Access Compliance Report

Public Rights-of-Way

(Curb Ramps)

Intersection ID: 17151	Main Street: E_INDEPENDENCE_BV	Cross Street: CONFERENCE_DR	Location: SE
ADA ID: 6B15B1A895B7	Ramp Type: Perp	Initial Pass/Fail: Fail	Overall Compliance: No
Severity Score: 1.25			
Codes/Mitigation Info/Possible Solution		Field Measurements/Component Compliance

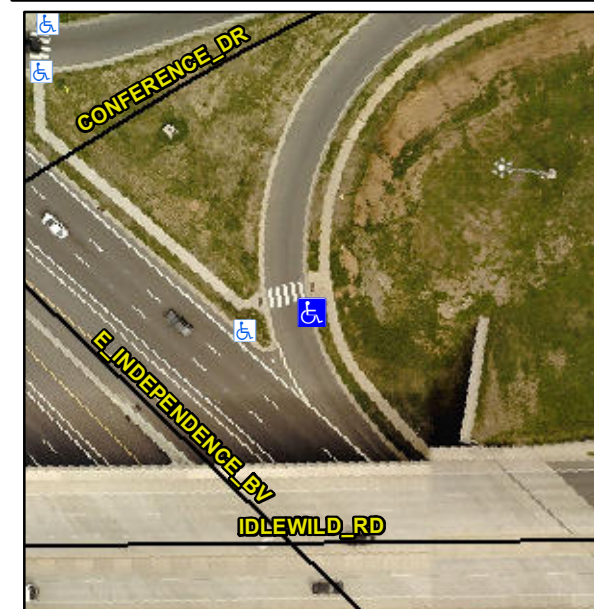
R304.5.3

Compliance	Description	Data	Compliance	Description	Data
N/A	Ramp Length (in)	64.0	Yes	Ramp Slope (%)	7.7
Yes	Ramp Width (in)	59.0	No	Ramp XSlope (%)	2.9
N/A	Flare Type LT	N/A	N/A	Flare Type RT	N/A
N/A	Flare Slope LT (%)	N/A	N/A	Flare Slope RT (%)	N/A
N/A	Flare Traversable LT?	N/A	N/A	Flare Traversable RT?	N/A
N/A	Landing Length (in)	N/A	N/A	DWS Provided?	N/A
N/A	Landing Width (in)	N/A	N/A	DWS Contrast?	N/A
N/A	Landing Slope (%)	N/A	N/A	DWS Length (in)	N/A
N/A	Landing X Slope (%)	N/A	N/A	DWS Full Width?	N/A
N/A	Landing Curb? (Y/N)	N/A	N/A	DWS Offset (in)	N/A
N/A	Shared Landing?	N/A			
N/A	Gutter Ponding?	N/A	N/A	Gutter Slope (%)	N/A
N/A	Gutter Lip Ht (in)	N/A	N/A	Gutter X Slope (%)	N/A
N/A	Painted X Walk1?	Yes	N/A	Painted X Walk2?	N/A
	X Walk 1 Direction	To W		X Walk 2 Direction	N/A
N/A	X Walk 1 Width (in)	120.0	N/A	X Walk 2 Width (in)	N/A
	X Walk 1 Slope (%)	8.5		X Walk 2 Slope (%)	N/A
	X Walk 1 X Slope (%)	2.8		X Walk 2 X Slope (%)	N/A

Remove & Replace Entire Ramp.
